UNITED STATES PATENT AND TRADEMARK OFFICE

10/594,849

Office Action Summary	Application No. 10/594,849	Applicant(s) BRAUER ET AL.	
	Examiner JERRY REDMAN	Art Unit 3634

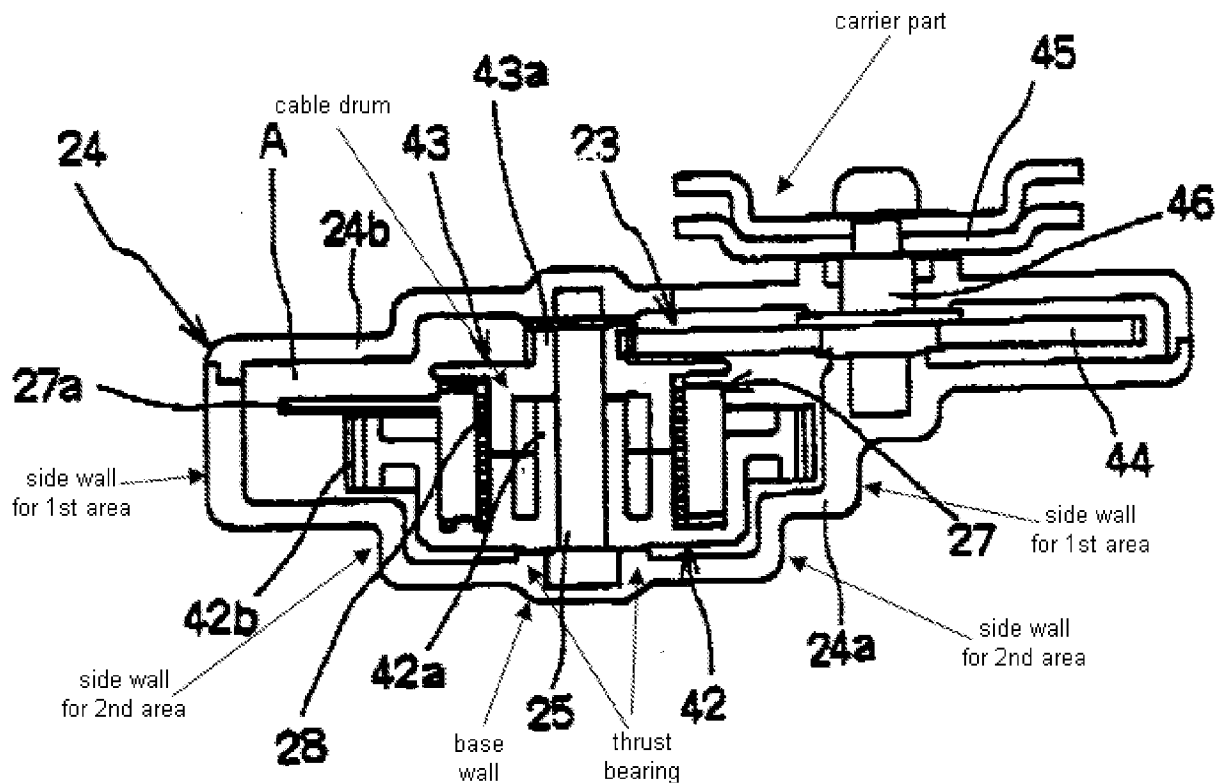
Claims 1-3, 5, 8-12, and 15 are rejected under 35 U.S.C. 102(b) as being anticipated by Shimizu (6,758,012 B2). As shown in detail below, Shimizu (6,758,012 B2) discloses a vehicle having a vehicle door (column 3, line 14, i.e.,) having a module (all inner mechanisms of a vehicle door), a carrier part (24) integrally formed with a drum housing (24a) having side walls, a back wall having a thrust bearing integrally formed thereon, and the housing (24a) having a first diameter area (see Figure below) and a second diameter area larger than the first diameter area (see Figure below).
